Title: Compost Leachate Pond
Improvements Project

**North Compost Leachate Pond Improvements Project
Bid No. 20214**

Addendum No. 1

Addendum No. 2

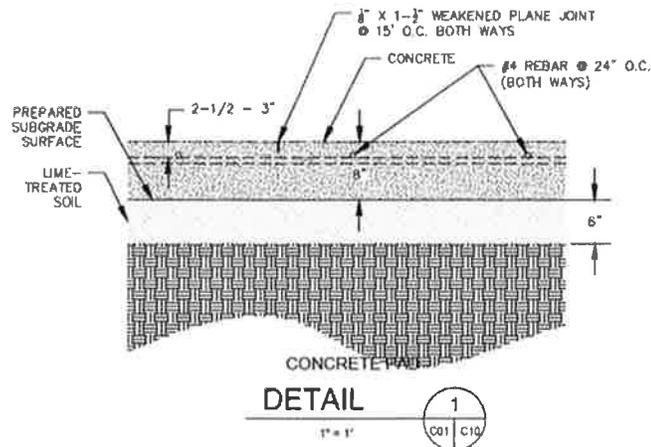
Q.2 Where will the entrance to the job site be located and what are the hours?

See sheet G02 for main site entrance location.

In Bid Book 1, Special Conditions, paragraph 1.3 E, replace the words "Site access is limited until the main facility gate is open at 7:00 a.m. on weekdays and 8:00 a.m. on weekends." with the following:

"Job site entrance shall be the main entrance off Athens Avenue. Gates are open from 7am to 5pm Monday through Friday and from 8am to 5pm on Saturday and Sunday. Hours may change on holidays. Additional, narrower, access is available generally all day and night via the staff parking lot on Fiddymment Road. See paragraph 1.11 C of this section."
